30 August 2021

RE: RESPONSE TO SUBMISSIONS FOR SSD-10224, NEW PRIMARY SCHOOL AT EDMONDSON PARK

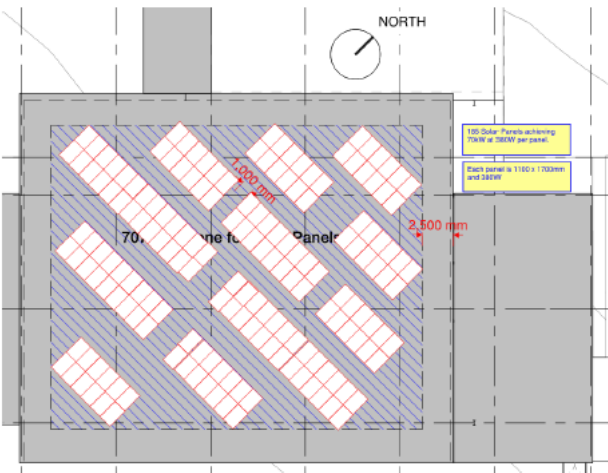
New pedestrian crossing to meet relevant warrants assessment and be approved by Council's Local Traffic Committee.	PTC confirm in Appendix 12 that the proposed pedestrian crossing meets the warrants as assessed in Section 7.4.1 of the Transport and Traffic Assessment dated 11 June 2021. It is noted the proposal will be put forward to Council's Local Traffic Committee for approval.

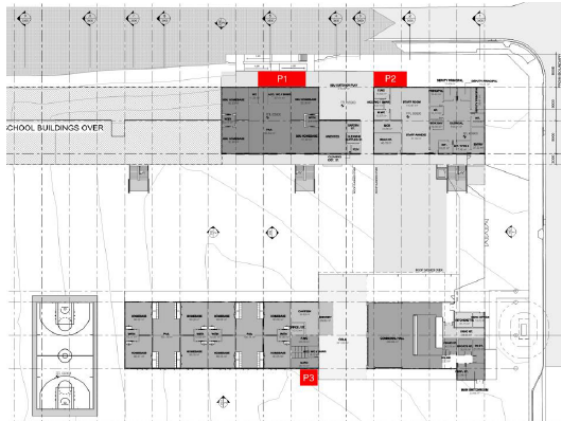
Sydney Trains	<p>Sydney Trains has requested several standard conditions be imposed in the consent relating to:</p> <ul style="list-style-type: none"> • Provision of an accurate survey locating development with respect to rail boundary; • Preparation of acoustic assessment and incorporate recommendations in construction drawings; • Engage Electrolysis Expert to prepare a report on Electrolysis Risk to the development from stray currents; • Provide certification from a qualified Geotechnical and Structural Engineer stating the proposed works are to have no negative impact on the rail corridor and associated infrastructure; • Ensure all drainage is adequately disposed of; 	<p>PTC Consultants has reviewed the standard conditions and consider them acceptable. The following mitigation measures address these:</p> <ul style="list-style-type: none"> • B30 • B9 • B31 • B32 • B12
